CITY OF PORT ST. LUCIE PROJECT#
 COPSL Project No.: P22-180
 PSLUSD File No.: 5336C

Landscape Key Sheet
 Landscape Construction Plans
 Belterra Tradition Phase II
 Port St. Lucie, Florida

REV.	DATE	DESCRIPTION	BY
3	02.07.23	Revision Per City Comments.	nfb
2	10.25.22	Revision Per City Comments.	nfb
1	08.01.22	Revision Per City Comments.	nfb

10' South Landscape Buffer
Landscape Construction Plans
Belterra Tradition Phase II
Port St. Lucie, Florida

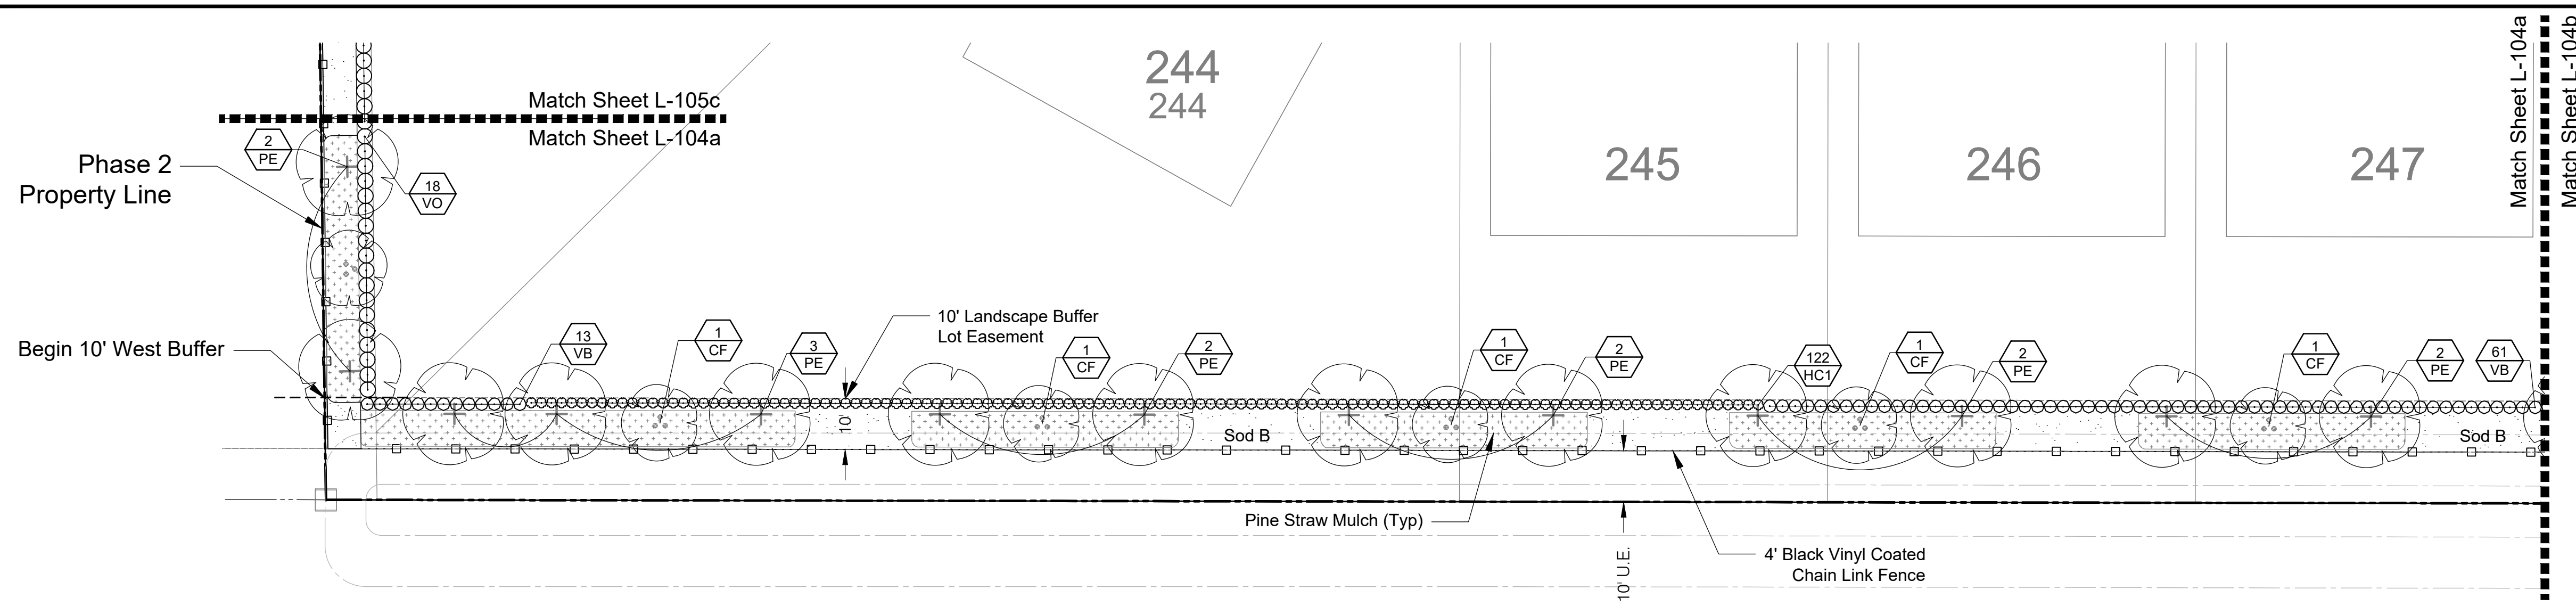
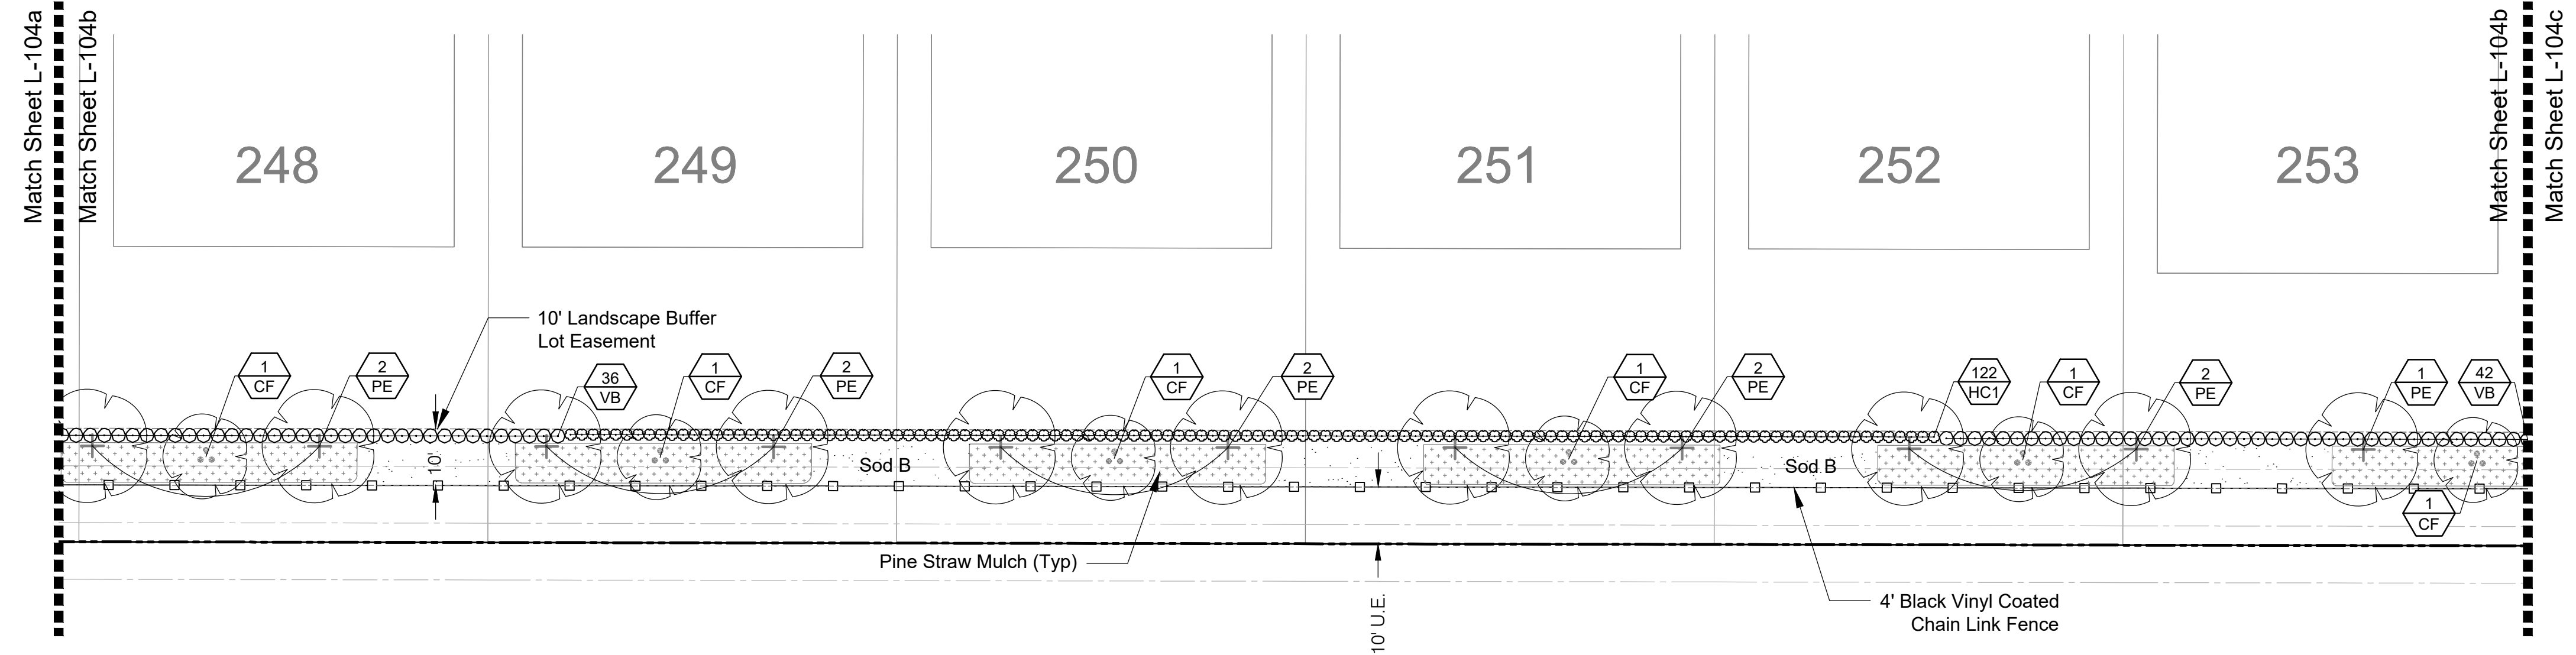
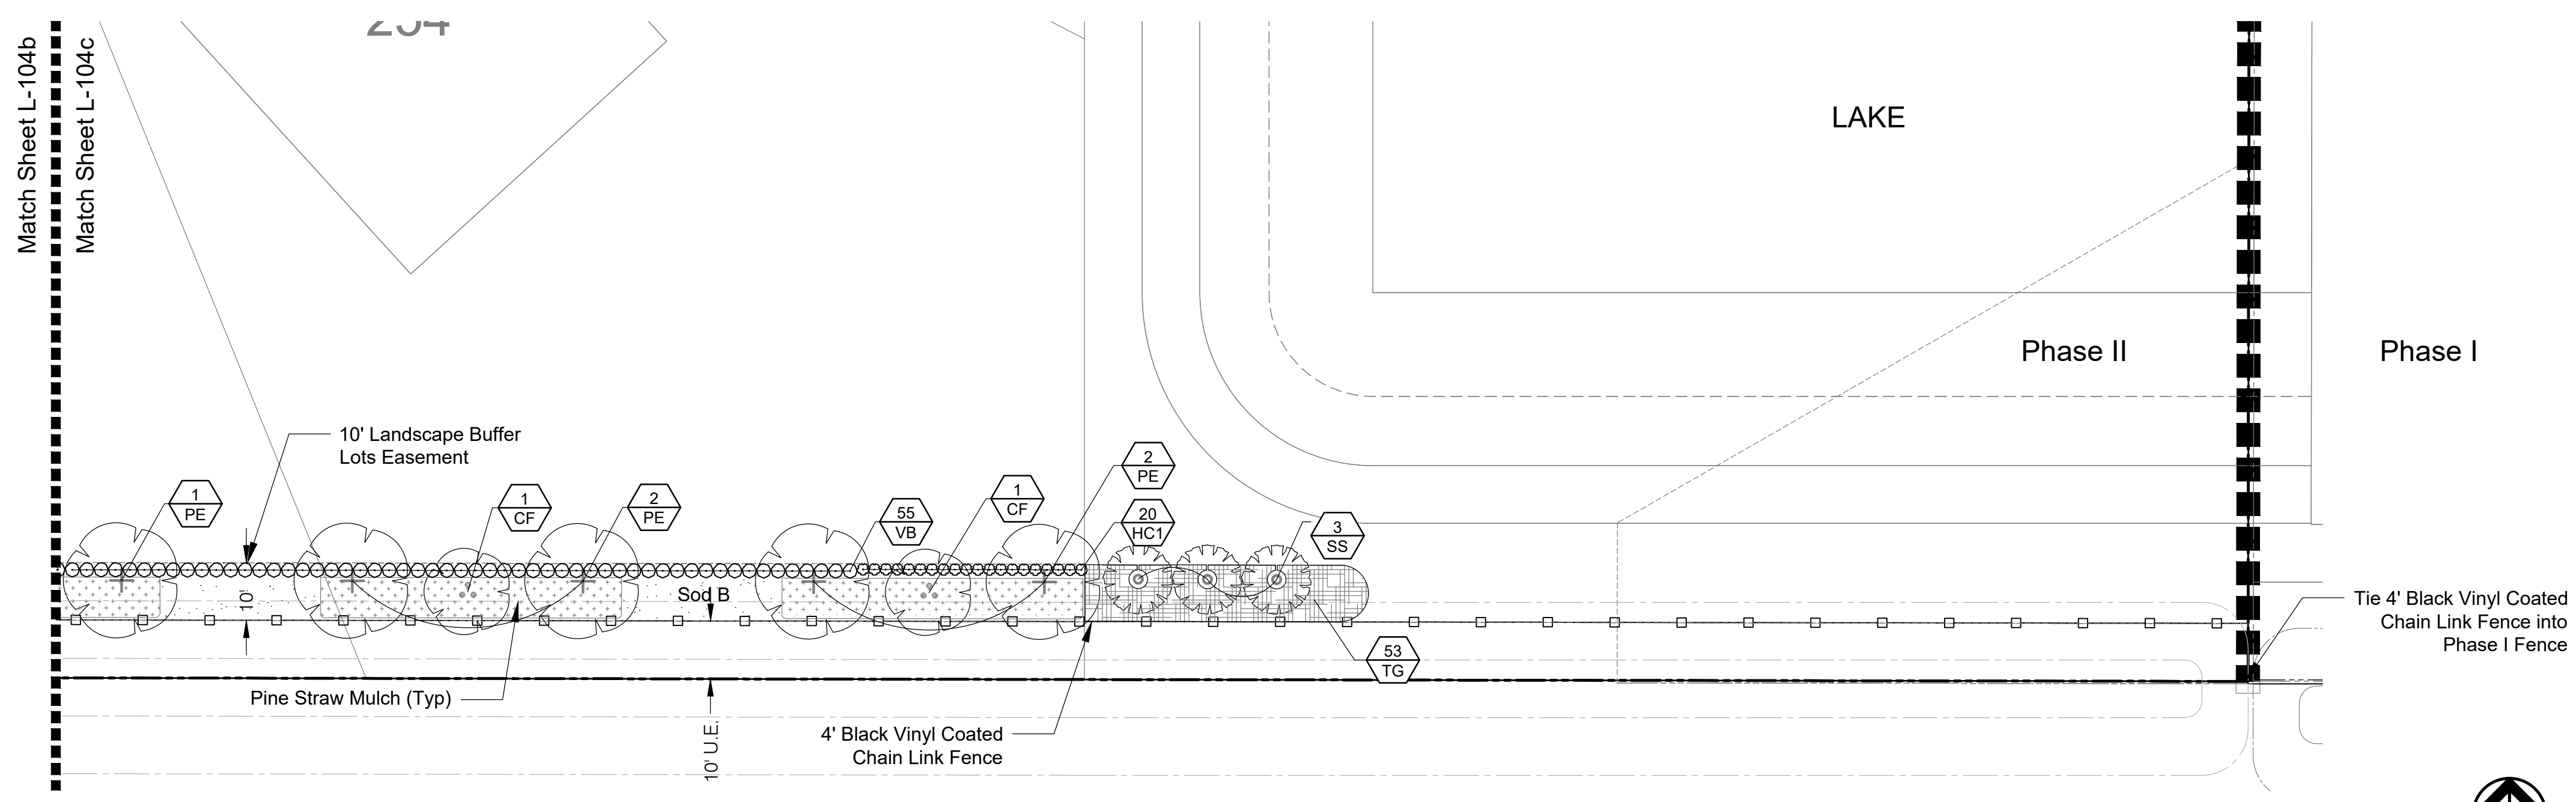
Revision ²
10' South Landscape Buffer moved to 10' easement on lots.

Street Tree Plan
Landscape Construction Plans
Belterra Tradition Phase II
Port St. Lucie, Florida

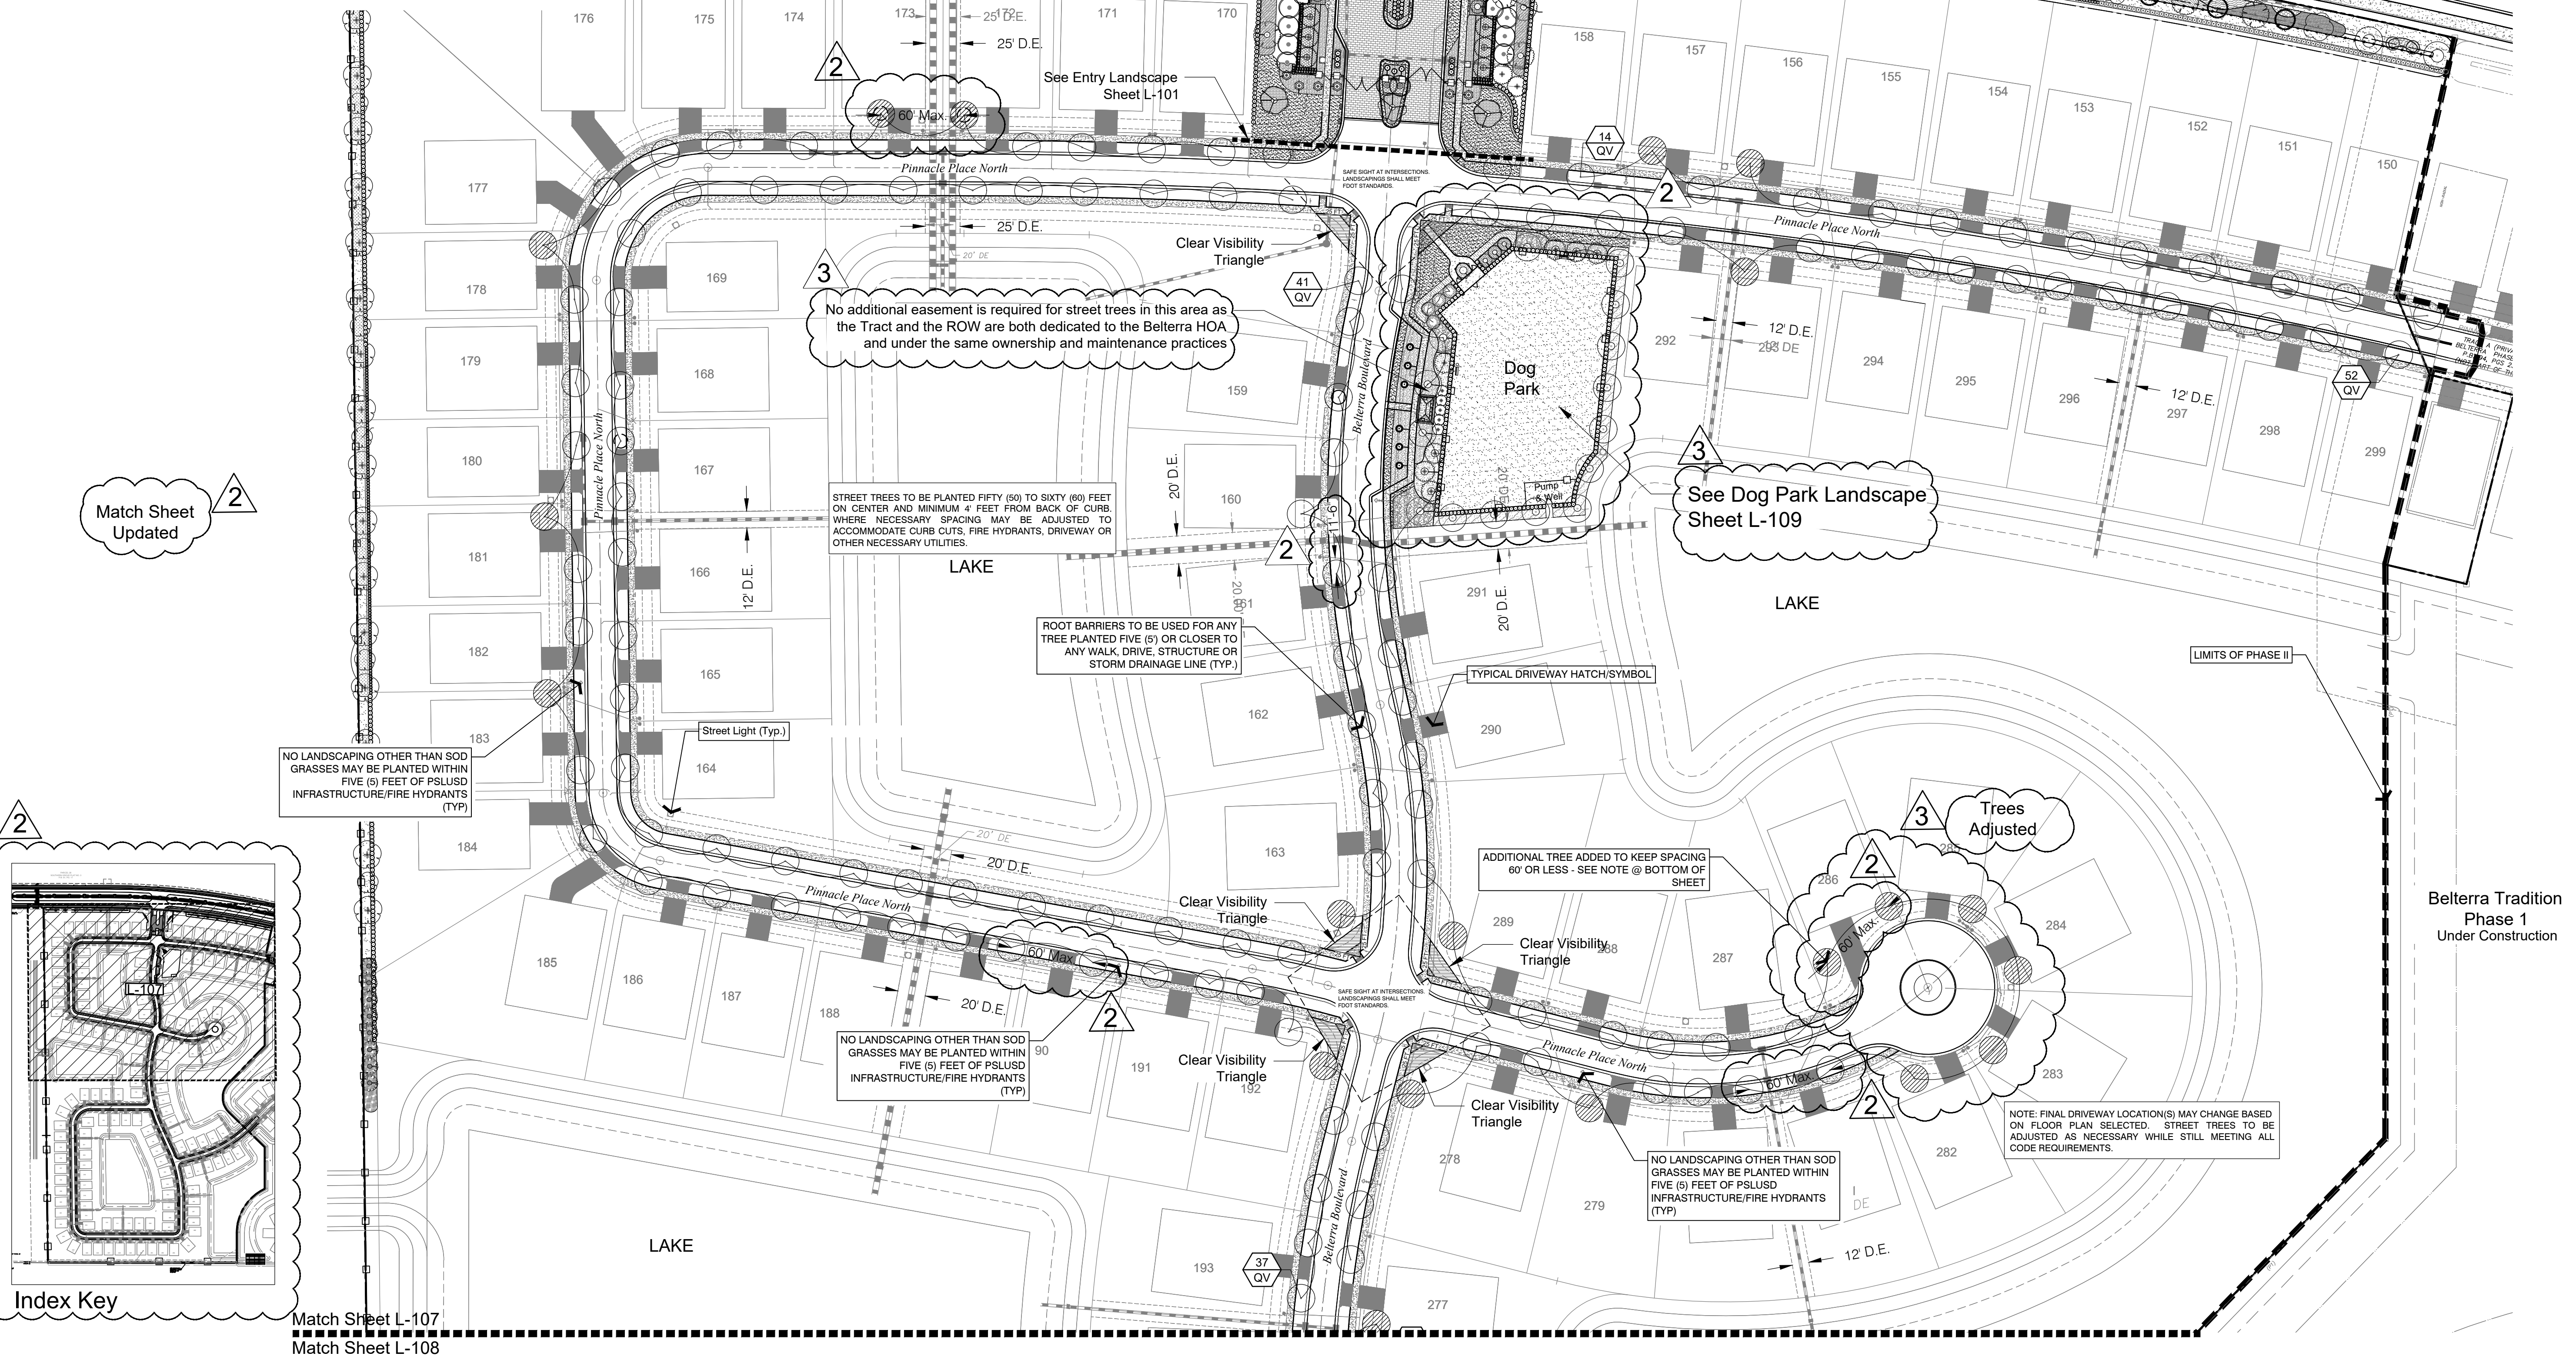
ADDITIONAL TREE ADDED TO KEEP SPACING 60' OR LESS - SEE NOTE @ TOP OF SHEET

ADDITIONAL TREE ADDED TO KEEP SPACING 60' OR LESS - SEE NOTE @ BOTTOM OF SHEET
